GJS Plot F, Manchester

Tower F2 - Podium Design | 26.04.2024

F2-SHP-A180-RP-XX-B5D803 | P04

Background to the report

View 6: Elevation PN2 - Main entrance

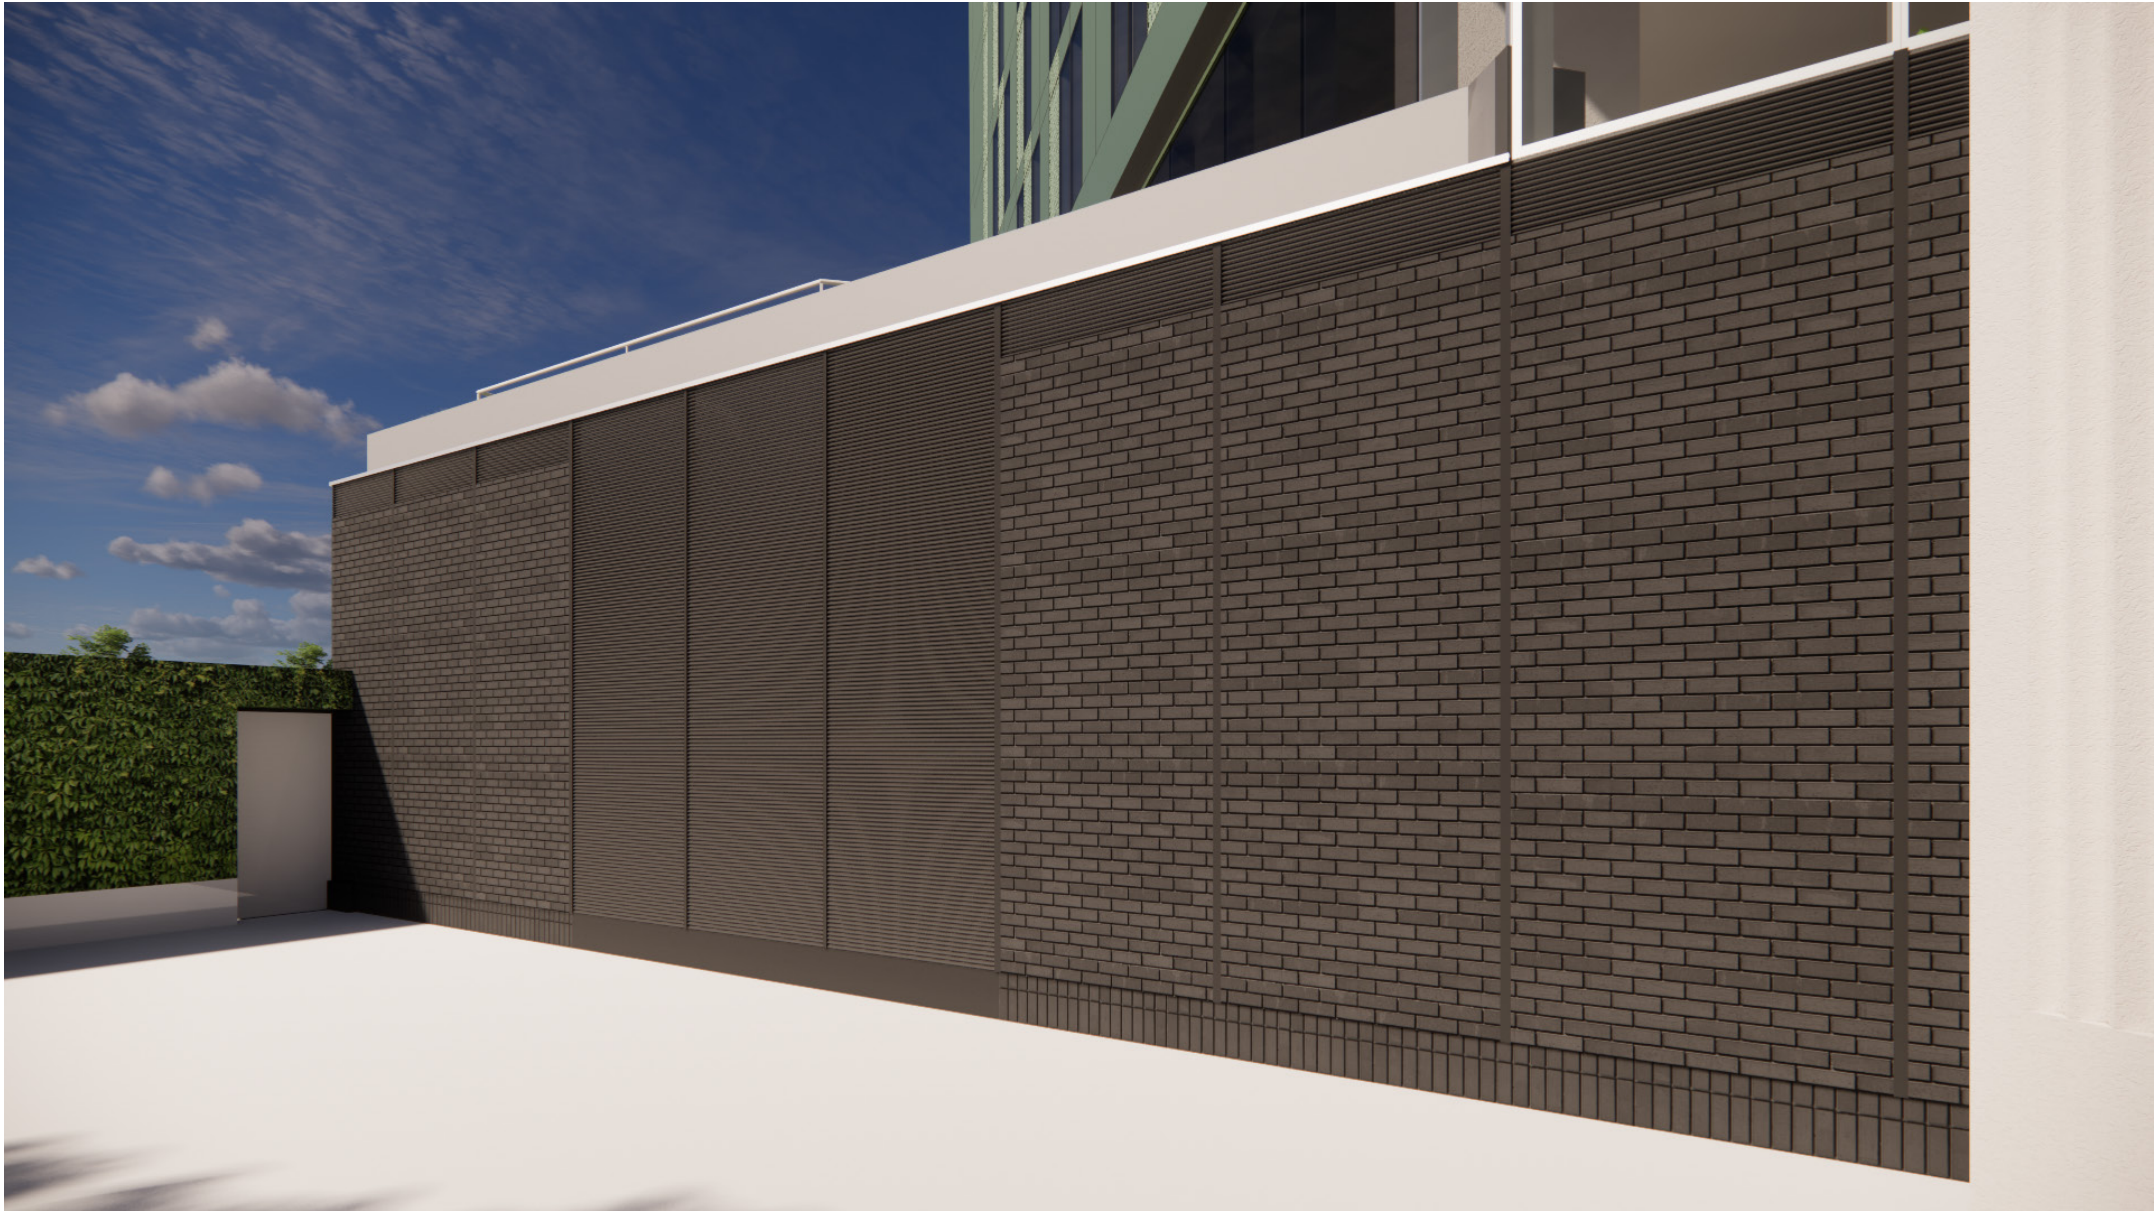
This document also reflects a design development taken place at the main entrance, where the canopy has been omitted. This is no longer deemed necessary to deal with the pedestrian wind conditions. Therefore the team considers the presence of the feature columns frames the main entrance sufficiently and the presence of the canopy is not required to signify it.

Updated Proposal - Decorative Screens, Canopy removed
